AGENDA
PLANNING COMMISSION REGULAR MEETING
Wednesday, March 15, 2023, at 6:00 PM

1. Appointment of Chair and Vice-Chair
 - Legislative
 - Staff Presentation: Nicholas Wharton, Town Manager
2. Resolution PC-2023-02R: Ziggi's Site Plan
 - Legislative
 - Staff Presentation: Abdul Barzak, Town Planner

Date: 9.12.22 Resubmitted: 12.16.22, 2.7.23
 Project Name/Contact: Ziggi's Severance/Paul Bass (TST)
 Project Address: 9843 E. Harmony Road
 Customer/Project Number: 284 - American Eagle Properties attn. Jerry Helgeson
 Review Number: 3rd Submittal
 Project Coordinator: Abdul Barzak, Town Planner
 Recipients:

SHEET: 9 of 15

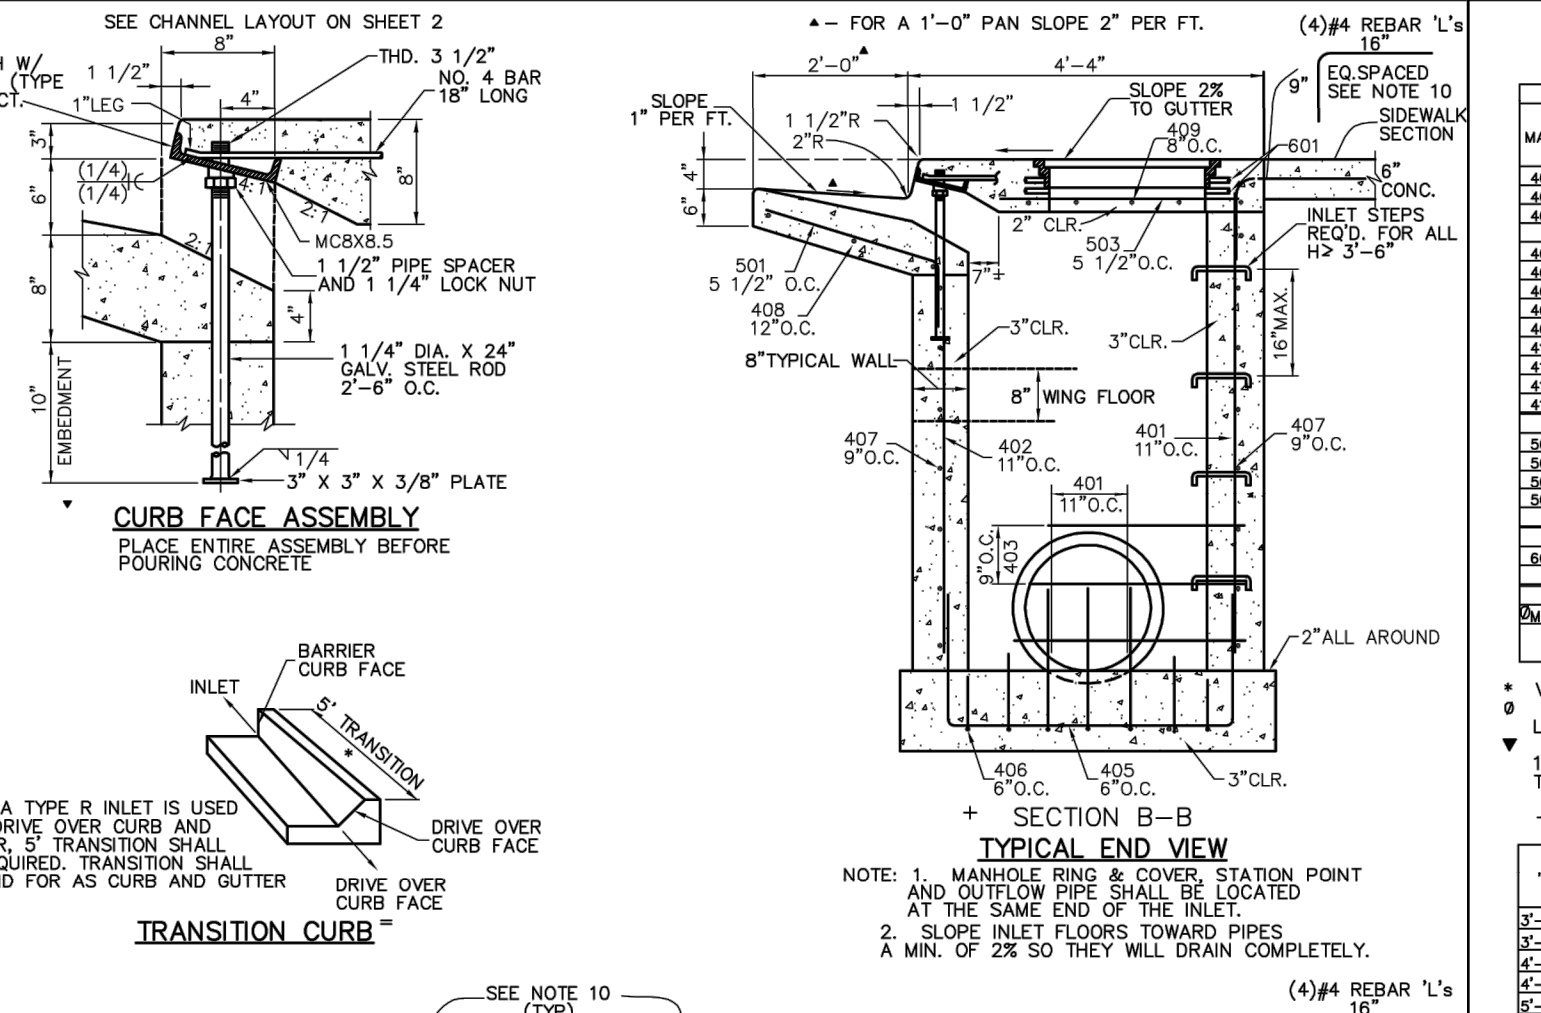
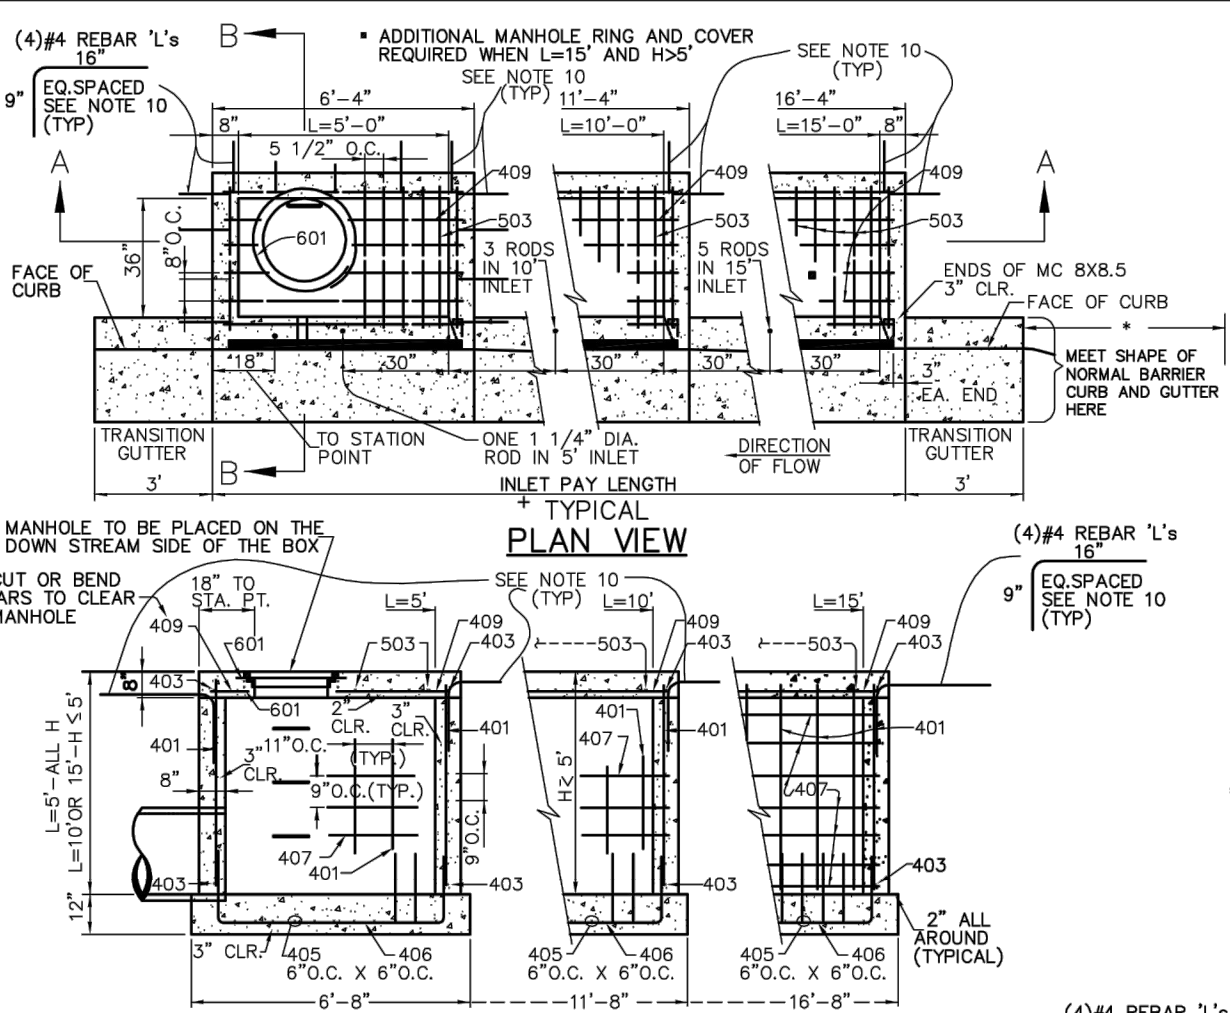
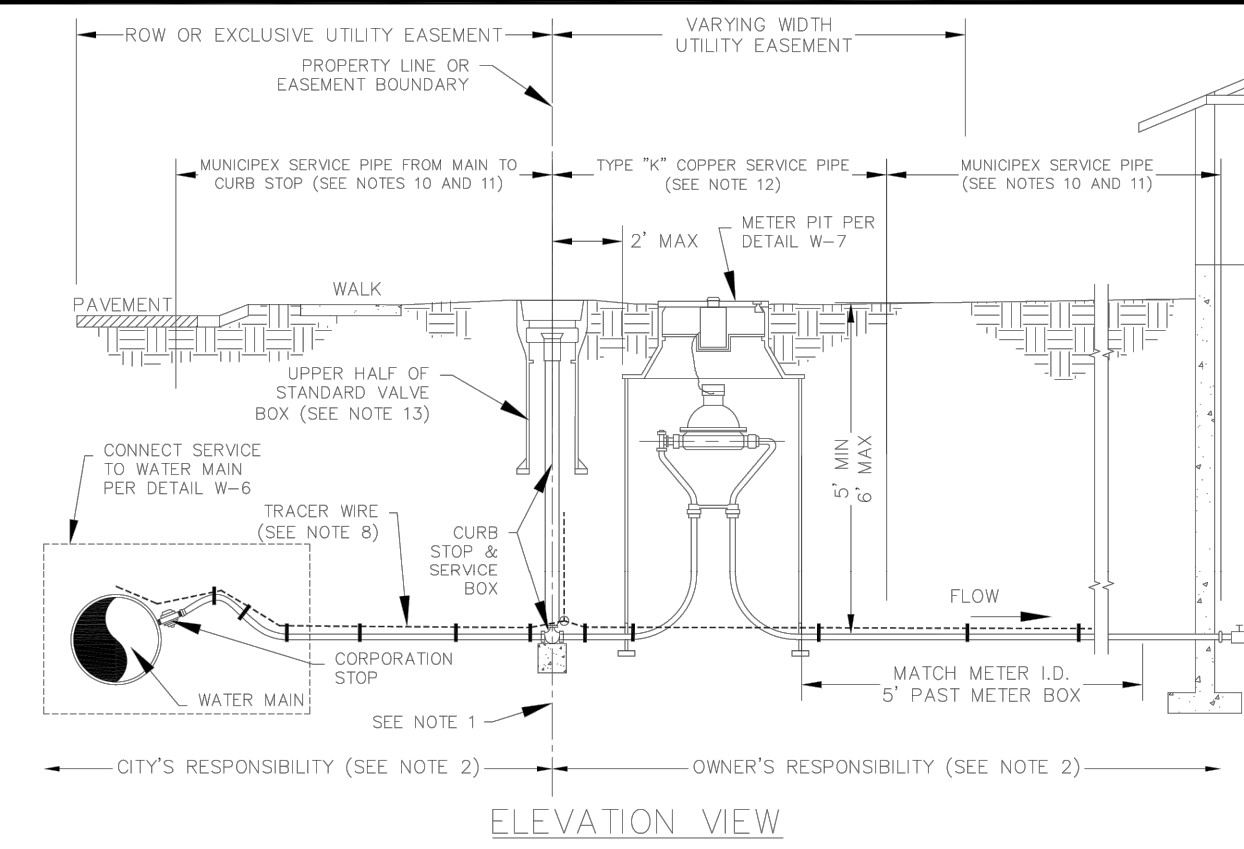
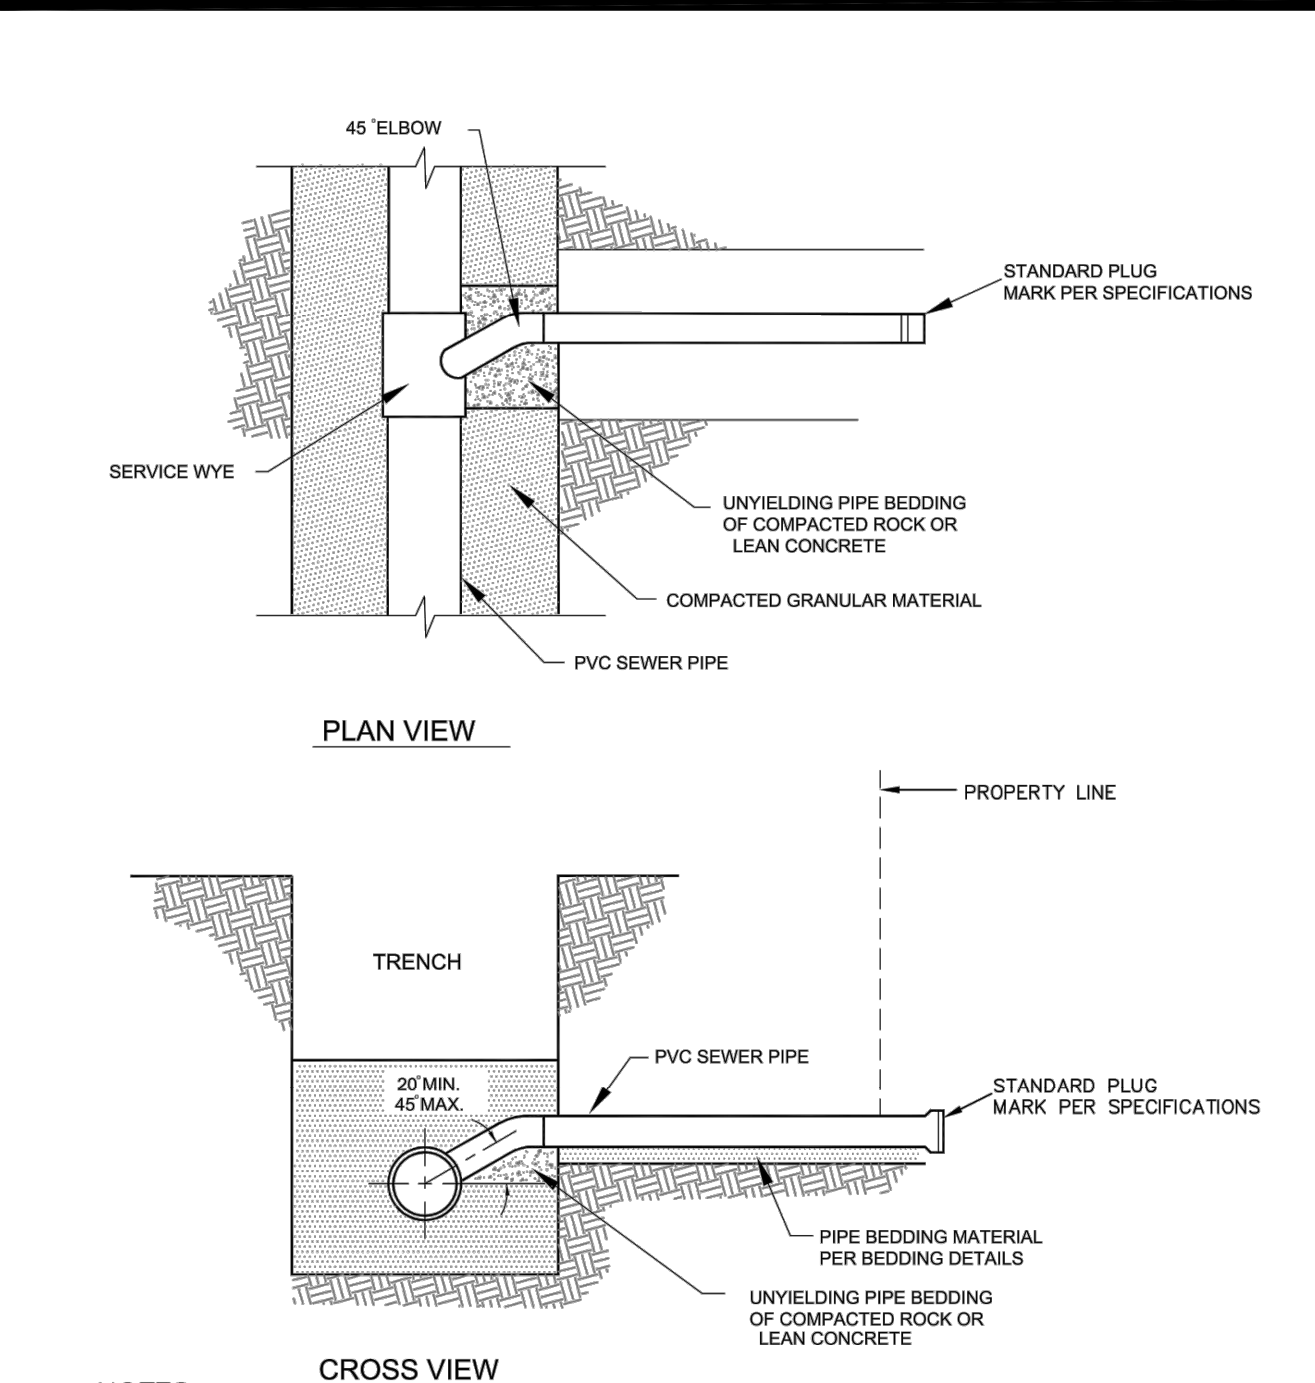
21. Sheets 9-10 (Water Details) – The City of Greeley has updated their Water and Sewer Design Criteria and Construction Specifications as of January 2023. The Town of Severance needs to review the updated 2023 City of Greeley details and determine which details are appropriate for this project.
22. Sheet 11 (Detail) - Add a pavement section detail for the Recommend Pavement Thickness for E Harmony Rd per Table 4 & 5 of the Geotechnical Report titled “Geotechnical Exploration Letter Harmony Centre Severance, Colorado” prepared by Olsson dated July 22, 2019 revised September 23, 2019. *(repeat)*
23. Refer to the Site Plan redlines for any additional comments.
